ADDENDUM

PROJECT: University of South Dakota
GEAR Building
Clean Room Modifications
Sioux Falls, South Dakota

AD-1

DATE ISSUED: Thursday, October 17, 2013

From Sheet: P-102	for CA use:
Drawing # P-102.1

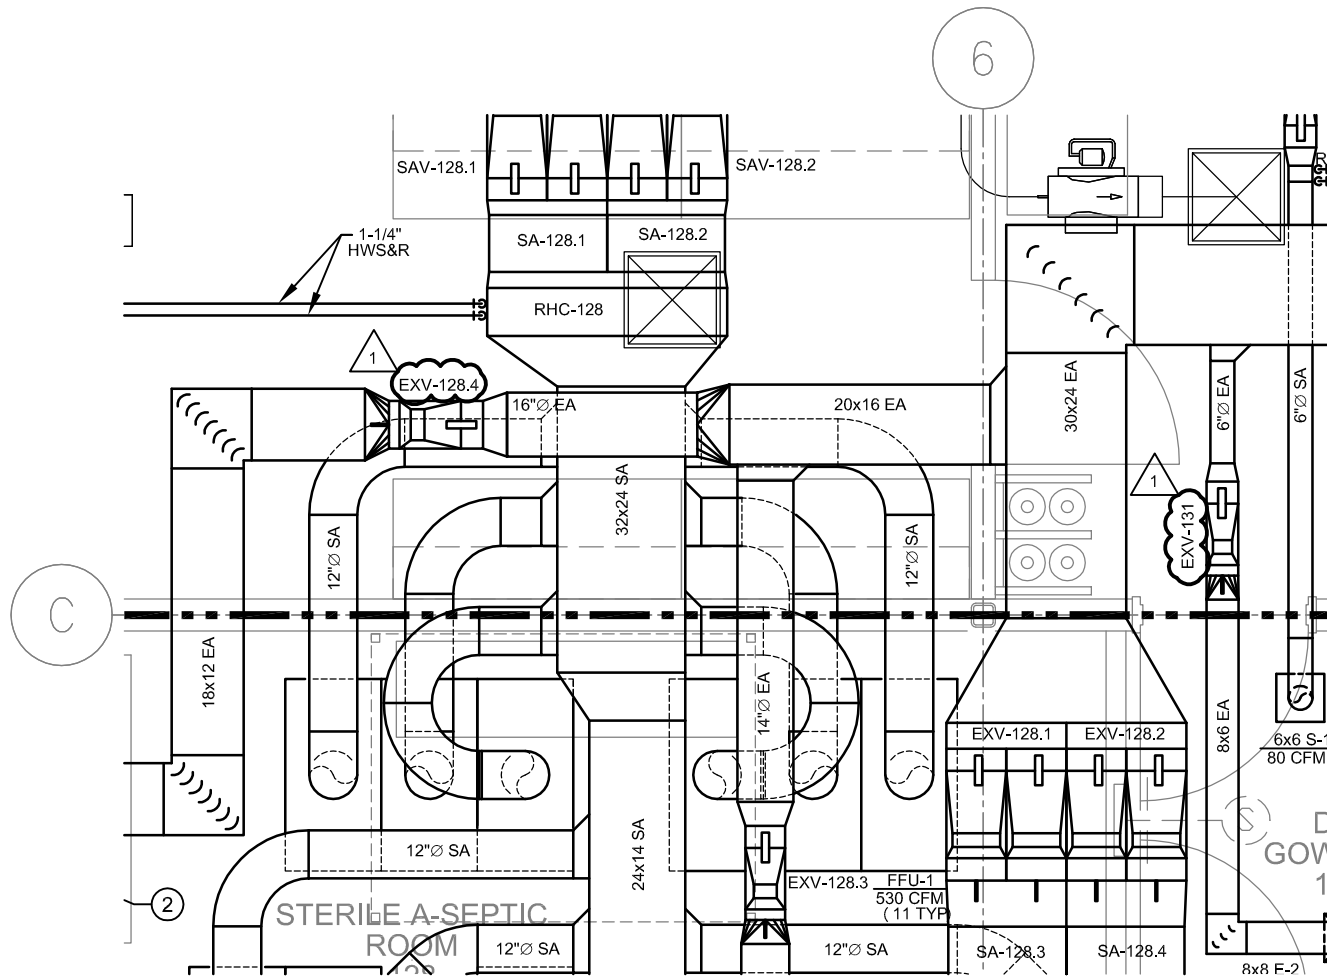
In reference to Sheet P-102 – First Floor Plumbing Plan, see attached drawing P-102.1 for modifications to the IDHWR, ICW and AV systems.

Drawing #
M-601.1

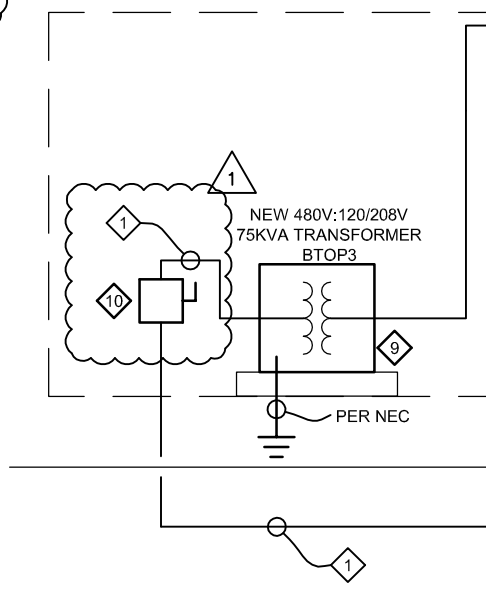
In reference to Sheet M-601 – Details and Schedules, see attached drawing M-601.1 for changes to Valve Schedule and Diffuser, Register and Grille Schedule.

From Sheet: E-601	for CA use:
Drawing # E-601.1

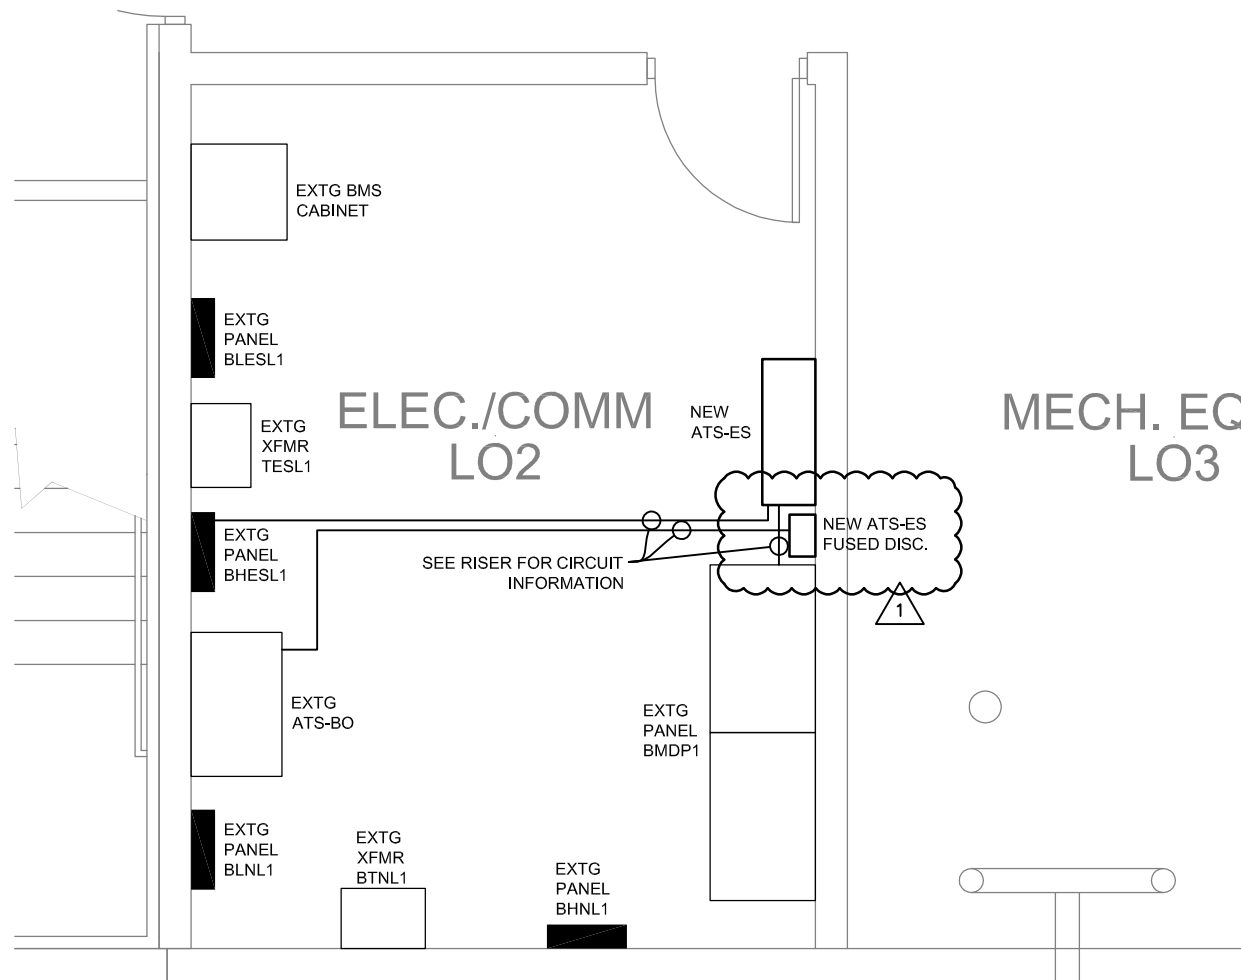
In reference to Sheet E-601 – Electrical Riser, Schedules and Legend, see attached drawing E-601.1 for changes to Detail 2.

(PARTIAL) KEYED NOTES (APPLICABLE TO DETAIL 2) :

- 1 PROVIDE NEW 100A AUTOMATIC TRANSFER SWITCH (ATS) IN ROOM ELEC/COMM LO2, SEE BASEMENT PLAN FOR LOCATION. ASCO 7000 SERIES ATS OR EQUAL. SEE SPECIFICATIONS FOR MORE DETAILS.

- 2 PROVIDE 4 - #1/0, 1- #6 G IN 1 1/2" CONDUIT BETWEEN EQUIPMENT. ROUTE ALL CONDUITS SURFACE MOUNTED OVERHEAD IN ELEC/COMM LO2. CONDUCTORS UPSIZED TO COMPLY WITH N.E.C. TAP RULE REQUIREMENTS.

- 3 AT EXISTING ATS-BO, REPLACE THE EXISTING TWO CONDUCTOR LUGS WITH THREE CONDUCTOR LUGS TO ACCOMMODATE THE TAP CONDUCTORS TO ATS-ES. CONTRACTOR SHALL COORDINATE WORK WITHIN THE EXISTING TRANSFER SWITCH TO AVOID OUTAGES TO EXISTING LOADS FED BY ATS-BO.

- 10 PROVIDE A HEAVY DUTY, 600V RATED, 200A FUSED DISCONNECT SWITCH IN NEMA 1 ENCLOSURE IN PENTHOUSE. PROVIDE WITH 150A FUSES. MOUNT ADJACENT TO TRANSFORMER BTOP3. ROUTE FEEDER TO PANEL BLO13 FROM TRANSFORMER THROUGH DISCONNECT SWITCH TO PANEL ON FIRST LEVEL.

- 11 PROVIDE A HEAVY DUTY, 600V RATED, 200A FUSED DISCONNECT SWITCH IN NEMA 1 ENCLOSURE TO SERVE NEW TRANSFER SWITCH ATS-ES. PROVIDE WITH 100A FUSES.
